Amdt. to ol/notorized 3/17/77...change to tech specs...to revise pressure-temperature limits for the first two effective years of full power operation....

FLORIDA POWER & LIGHT COMPANY

March 17, 1977
L-77-82

Re: St. Lucie Unit 1
 Docket No. 50-335
 Proposed Amendment to
Facility Operating License DPR-67

FIGURE 3.4-2a

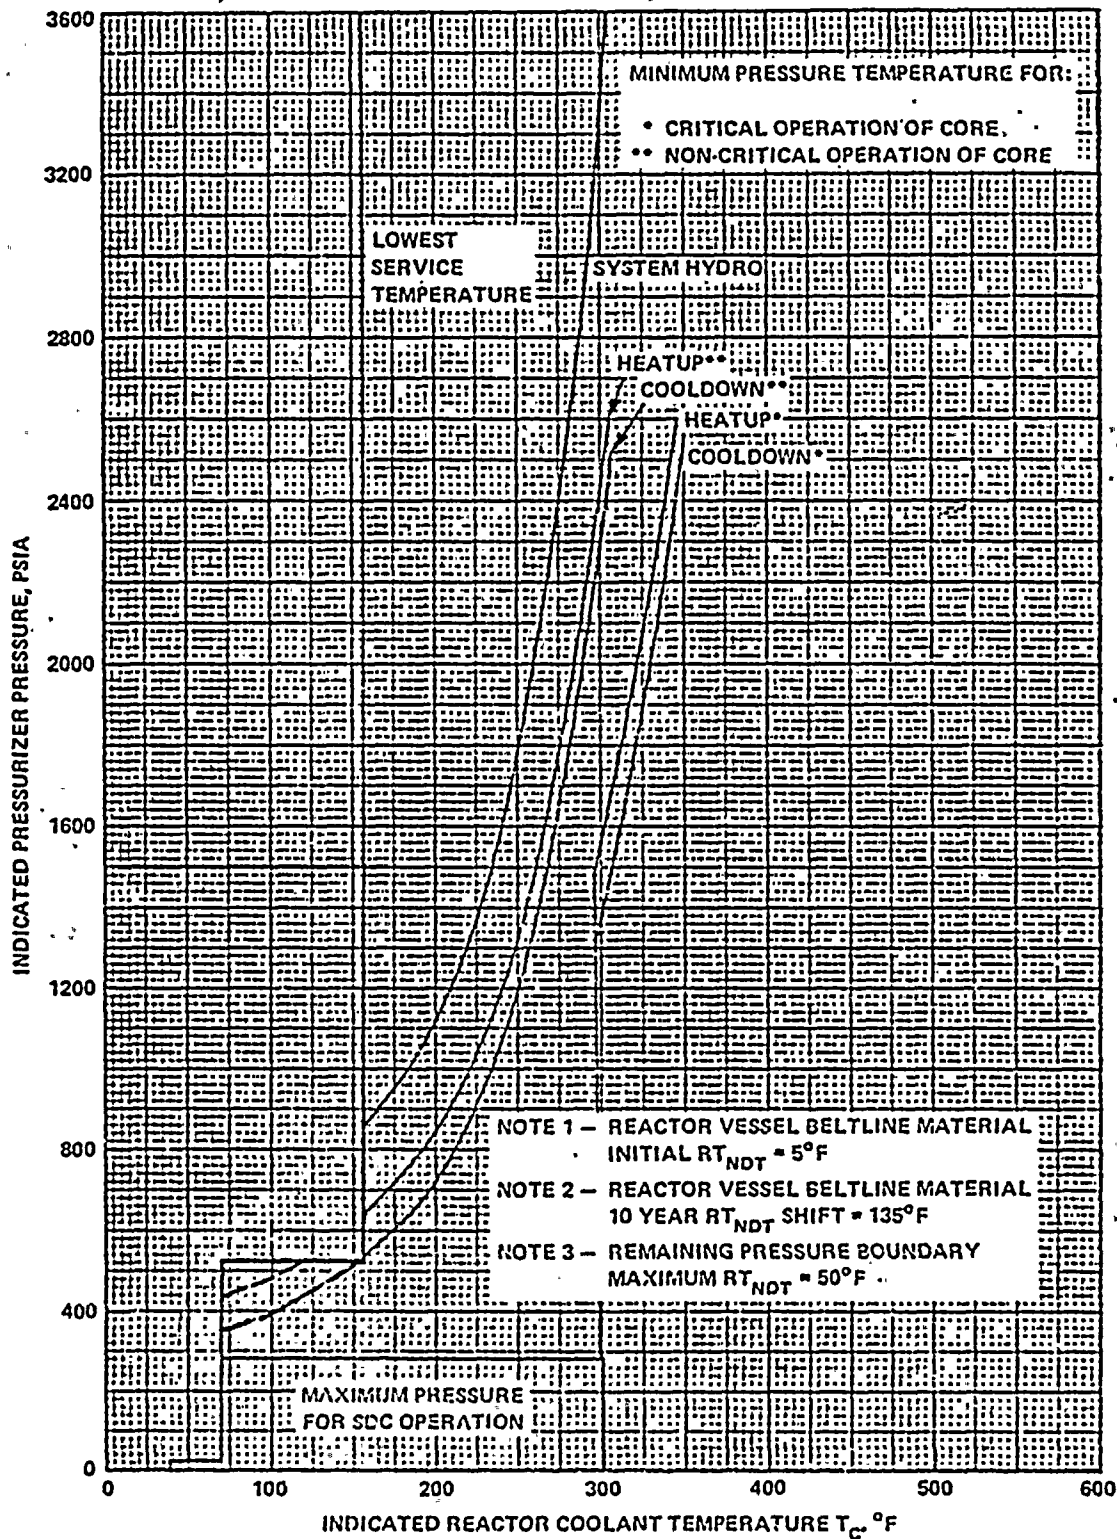
A letter from your staff dated February 15, 1977 requested that we revise our pressure-temperature limits for the first 2 effective years of full power operation (Technical Specification Figure 3.4-2a) to provide additional margin to assure compliance with Appendix G to 10 CFR Part 50. We have studied several references (SRP 5.3.2, BTP MTEB No. 5-2, and Appendix G to 10 CFR Part 50) dealing with fracture toughness requirements and have developed a new curve with which to replace Figure 3.4-2a. Our new curve conservatively depicts operating conditions for up to 5 effective years of full power operation. We propose that our new curve be approved for use in place of the current Figure 3.4-2a.

A new Figure 3.4-2a is provided entitled "Reactor Coolant System Pressure Temperature Limitations for up to 5 years of Full Power Operation".

This relationship has been used to develop a new Technical Specification Figure 3.4-2a. The new curve is applicable for up to 5 years of full power operation.

A minimum RT_{NDT} shift of 95°F is necessary to satisfy Equation (1). A 95°F shift is midway between the 55°F shift of the current Figure 3.4-2a and the 135°F shift of Figure 3.4-2b. To develop a new Figure 3.4-2a that will satisfy Equation (1), the 10-year curves of Figure 3.4-2b were shifted 40°F to the left. This technique is justified based on paragraph 3c of section III to Standard Review Plan 5.3.2 (Pressure-Temperature Limits).

The attached figures show the pressure-temperature curves for $RT_{NDT} = 95^{\circ}\text{F}$ and a semi-logarithmic plot of fluence vs. service life. The service life plot shows that, after 5-1/2 years of full power operation, the vessel surface has been exposed to a fluence of $1.95 \times 10^{18} \text{ n/cm}^2$. Thus, the new pressure-temperature curves conservatively depict operating conditions for up to 5 years of full power operation.

FIGURE 3.4-2b

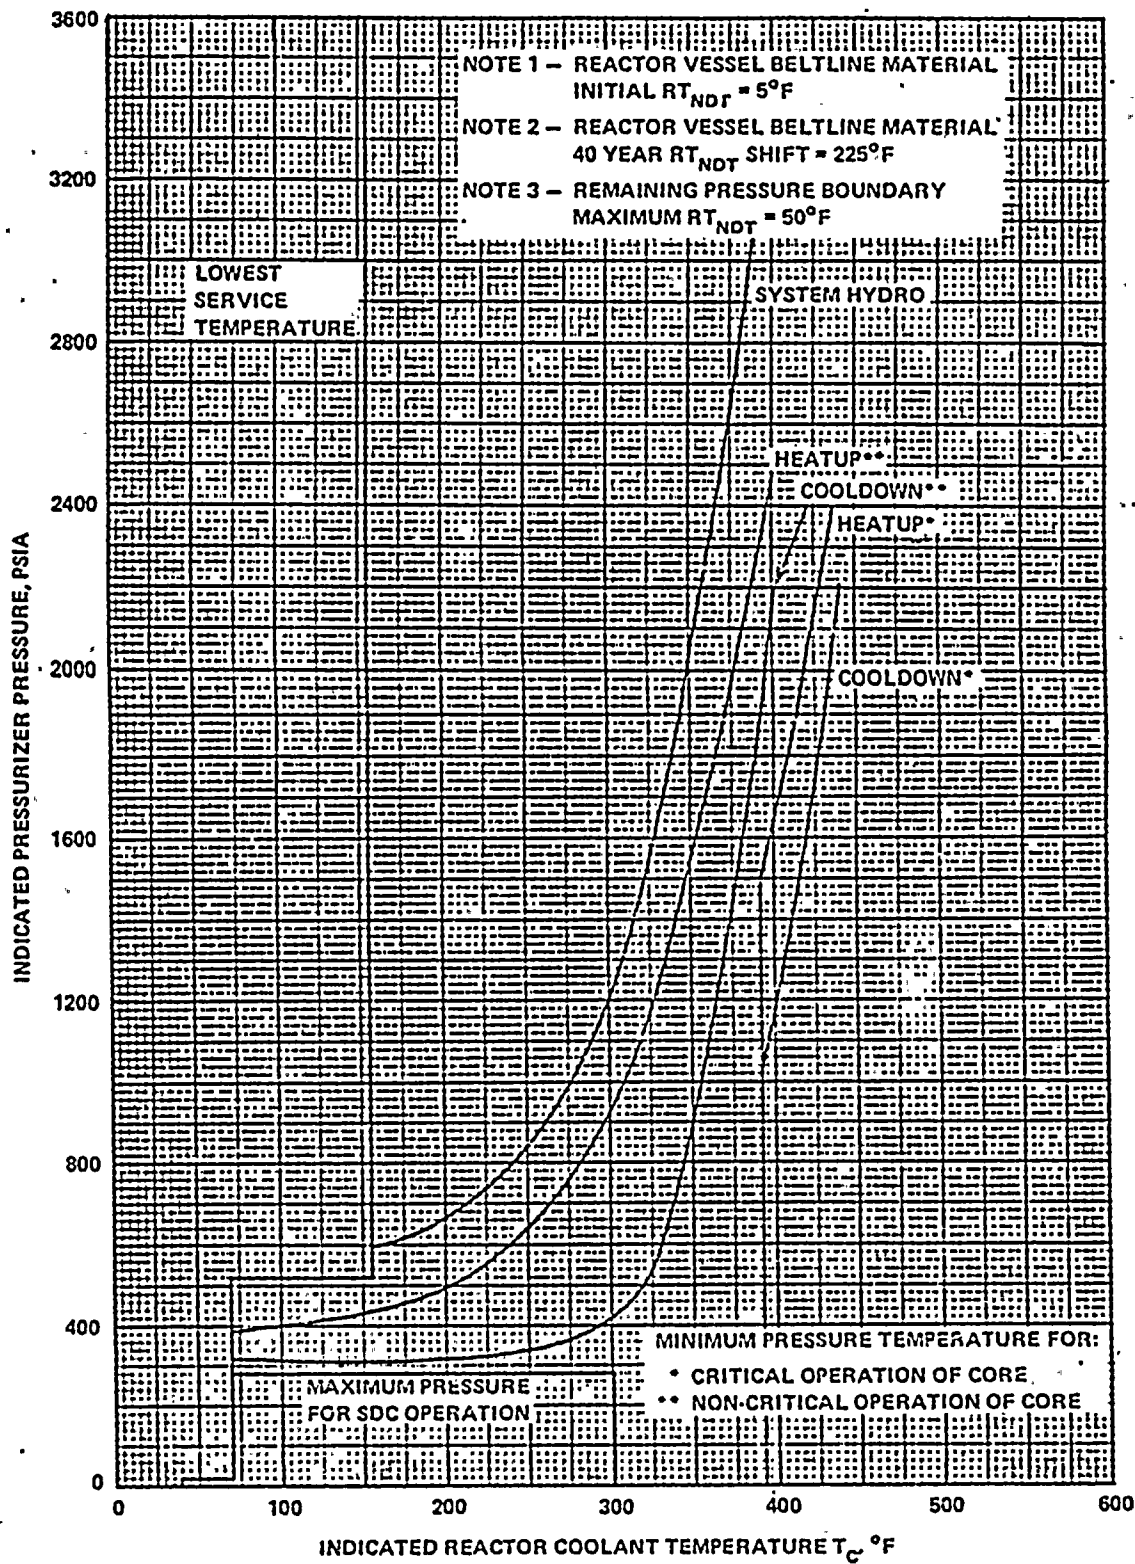
The title of Figure 3.4-2b is revised to read "Reactor Coolant System Pressure Temperature Limitations for up to 10 Years of Full Power Operation".

Since the pressure temperature curves represent an upper boundary on service life, the titles are revised to read "up to 10 Years" and "up to 40 Years" instead of "2 to 10 Years" and "10 to 40 Years", respectively.
